Agenda
Village of Arlington Heights
Design Commission
Community Room, 3rd Floor

Arlington Heights Village Hall
33 S. Arlington Heights Road
Arlington Heights, IL 60005
September 20, 2016
6:30 PM

**MINUTES OF
THE VILLAGE OF ARLINGTON HEIGHTS
DESIGN COMMISSION MEETING
HELD AT THE ARLINGTON HEIGHTS MUNICIPAL BUILDING
33 S. ARLINGTON HEIGHTS RD.
AUGUST 23, 2016**

LANDSCAPE PLAN

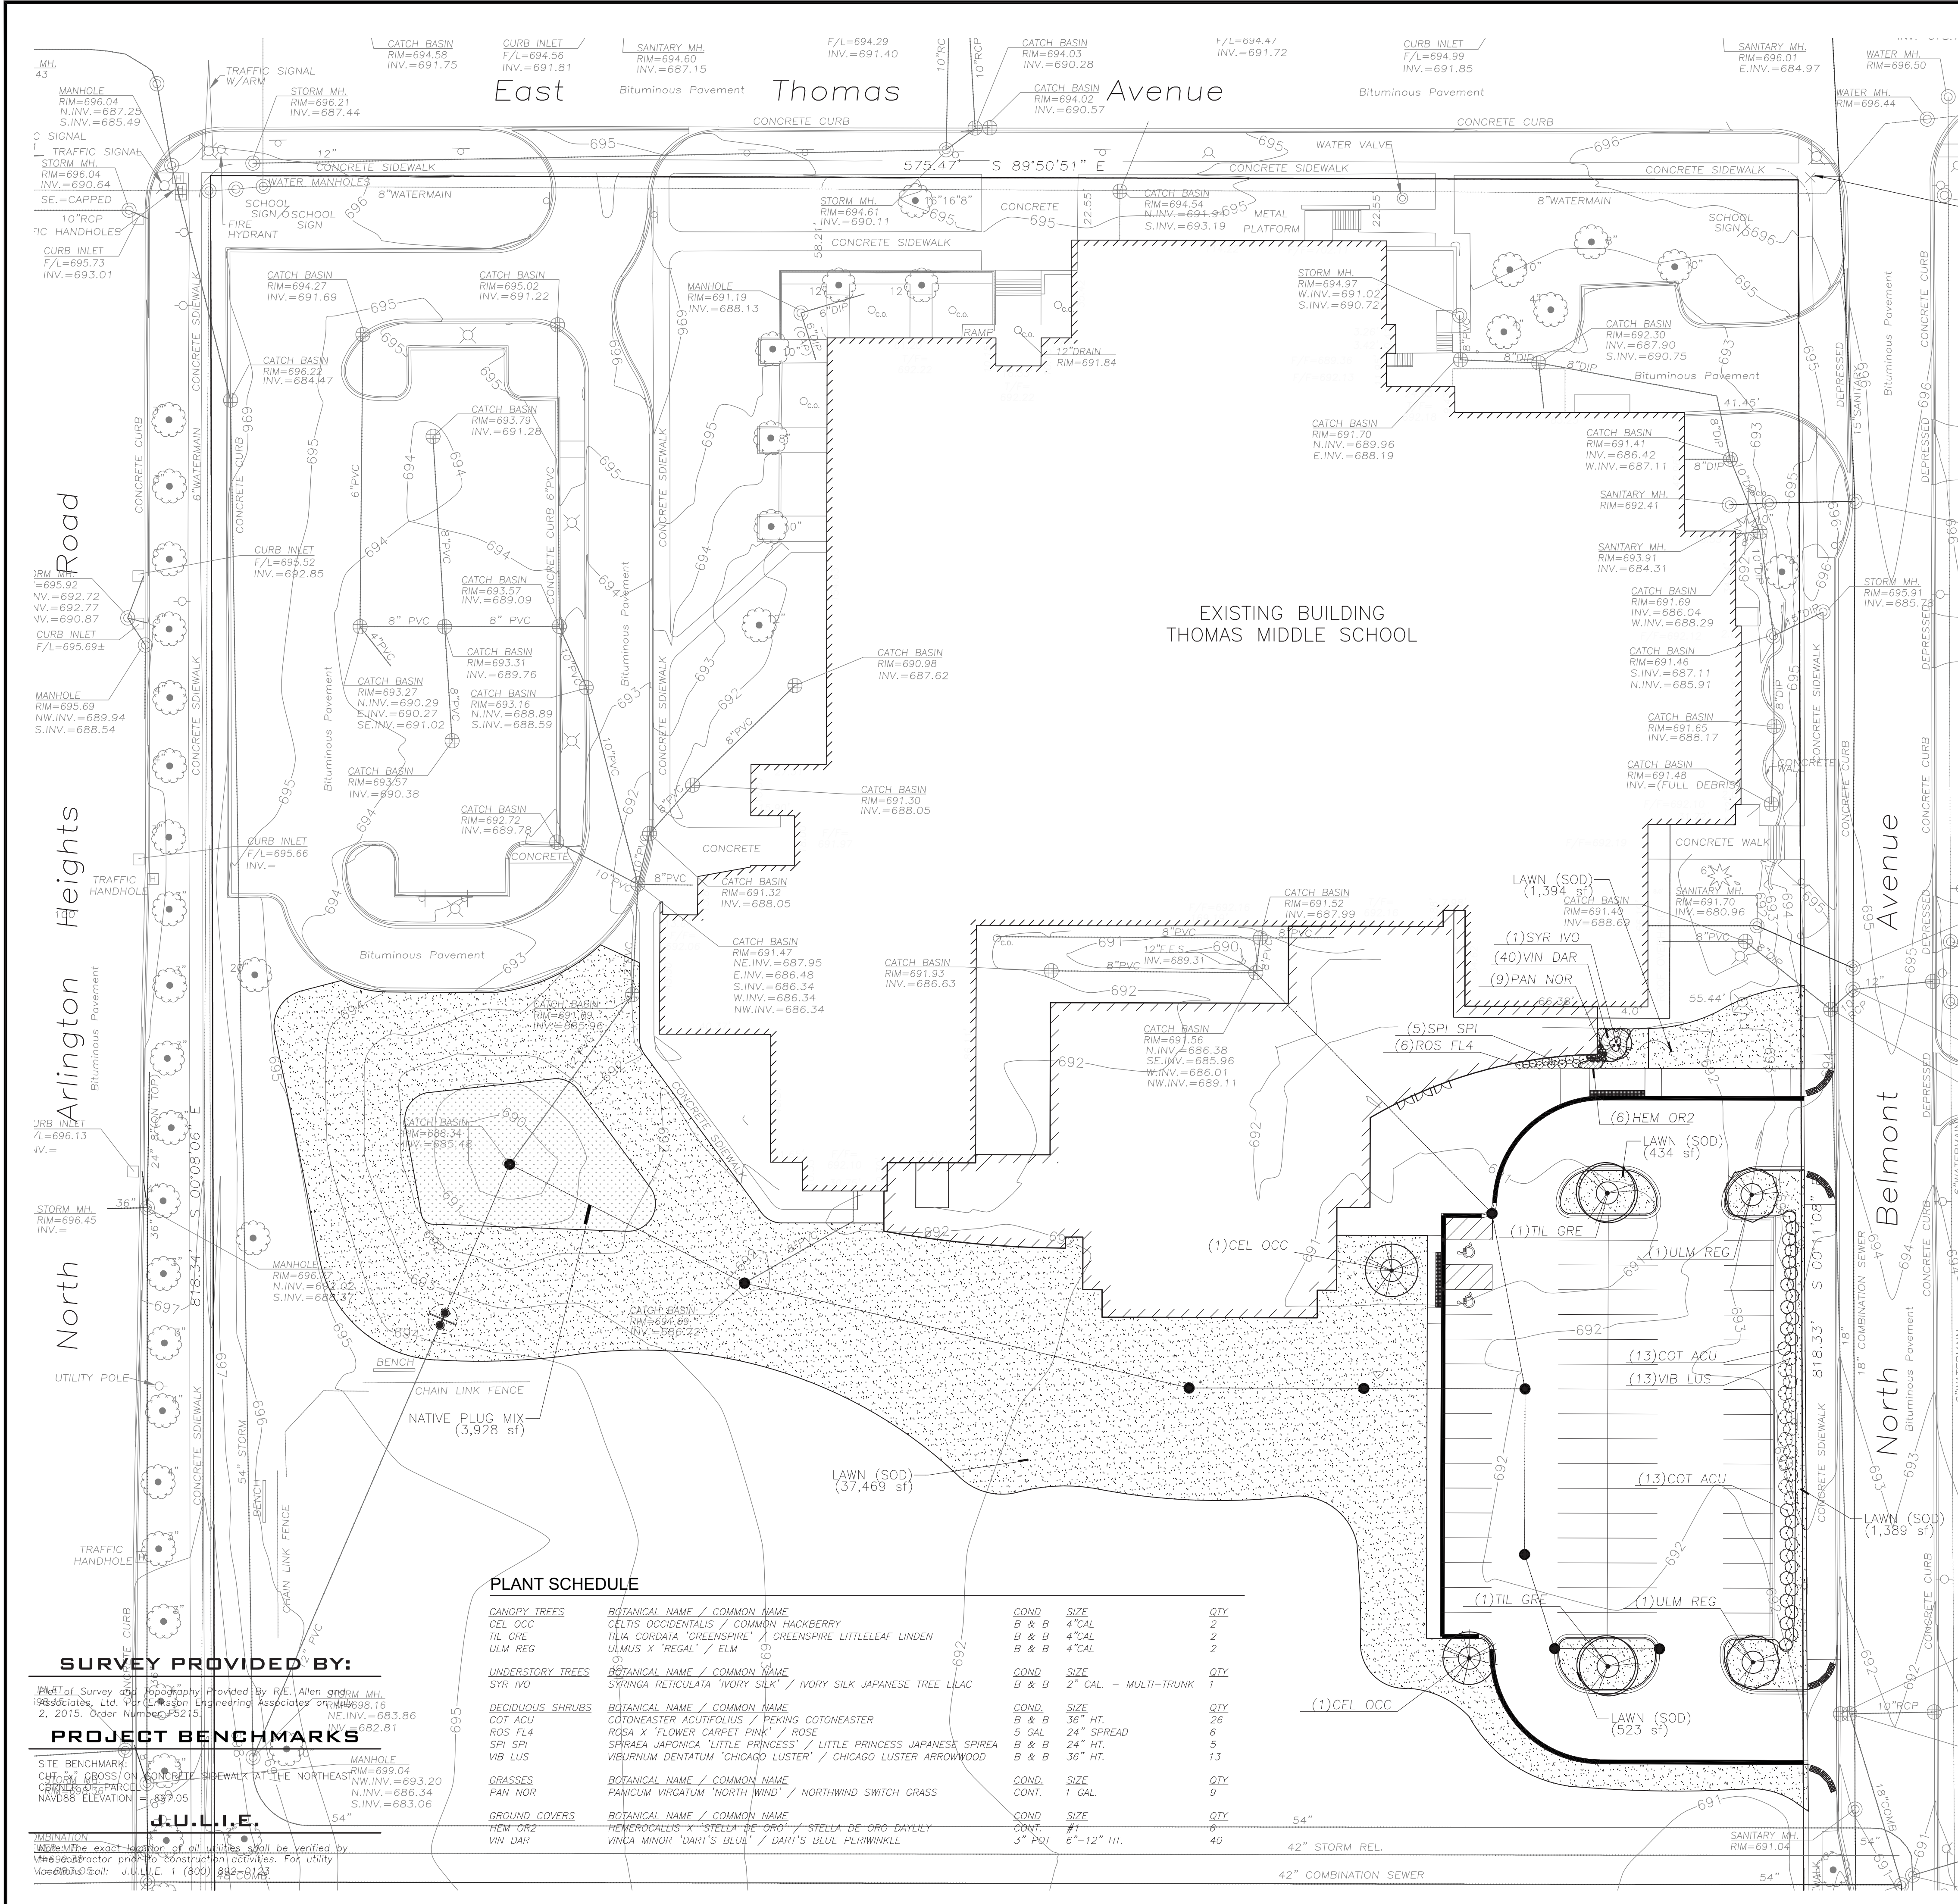
New landscaping is proposed along Belmont to provide screening of the new parking lot, and trees are proposed within the new parking lot islands. As part of the Plan Commission process, additional trees will be required in order to comply with the code requirement for a 4" caliper shade tree at the end of all parking rows, with two trees provided where there is a double row of parking.

Landscaping is proposed along the new building wall at the north end of the entry plaza, but additional landscaping is suggested along the building wall at the south end of the entry plaza.

1. Suggest / Evaluate additional landscaping along the new building wall at the south end of the entry plaza.
2. This review deals with architectural design only and should not be construed to be an approval of, or to have any other impact on nor represent any tacit approval or support for the proposed land use or any other zoning and/or land use issues or decisions that stem from zoning, building, signage or any other reviews. In addition to the normal technical review, permit drawings will be reviewed for consistency with the Design Commission and any other Commission or Board approval conditions. It is the architect/homeowner/builder's responsibility to comply with the Design Commission approval and ensure that building permit plans comply with all zoning code, building permit and signage requirements.
